**From:** Caroline McHardy  
**Sent:** 05 October 2020 18:01  
**To:** Markwell, Jonathan (Jonathan.Markwell@reading.gov.uk)  
**Cc:** Craig Pettit  
**Subject:** FW: 55 Vastern Road, Reading (200188) - energy  
**Attachments:** 200918 SB Vastern Road Energy Strategy Review - HC Comments 05.10.20.docx

# Memo: Vastern Road energy strategy – updated review

The following memo provides Reading Borough Council (RBC) with an updated review of Hodkinson’s energy strategy for the Vastern Road development.

Figure 2 Revised analysis of annual cost of heat for Vastern Road residents

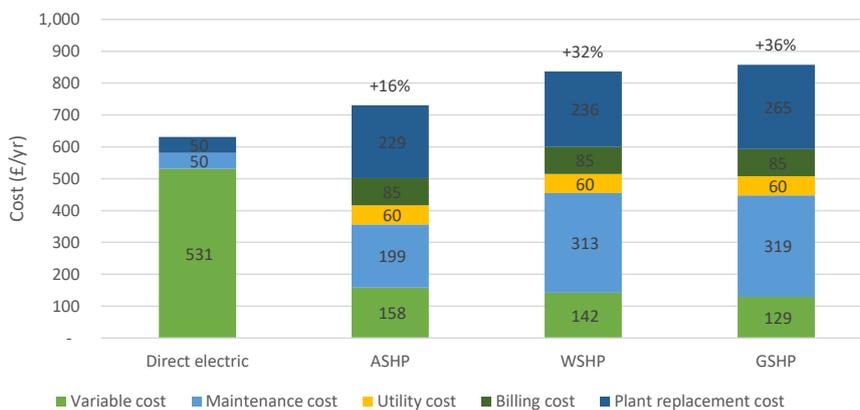
The results of the above assessment are provided in Figure 2. All communal heat pump options remain higher cost than the direct electric strategy proposed by Hodkinson, however the differences are significantly reduced, by at least half in all cases. The ASHP option has only a 16% higher annual heat cost than direct electric, relative to 49% from Hodkinson's analysis. With reasonable and justifiable changes to the assumptions made, the communal ASHP option looks much more reasonable relative to the direct electric strategy. Further changes could be investigated once sources of data are provided by Hodkinson (e.g. manufacturer costs for heat pump units, which are considered to be on the high side in their analysis).

**Commented [JP10]:** Even taking into account all the best-case assumptions for the communal alternatives (replacement costs, maintenance, price of electricity, heat losses), the proposed direct electric heating strategy is still the most cost-effective to residents. It is also not considered responsible to assume best-case costs in all areas, as this is highly unlikely to be delivered in practice – thus the increase from the proposed strategy to a communal one is expected to be nearer what is shown in the Hodkinson Consultancy cost analysis
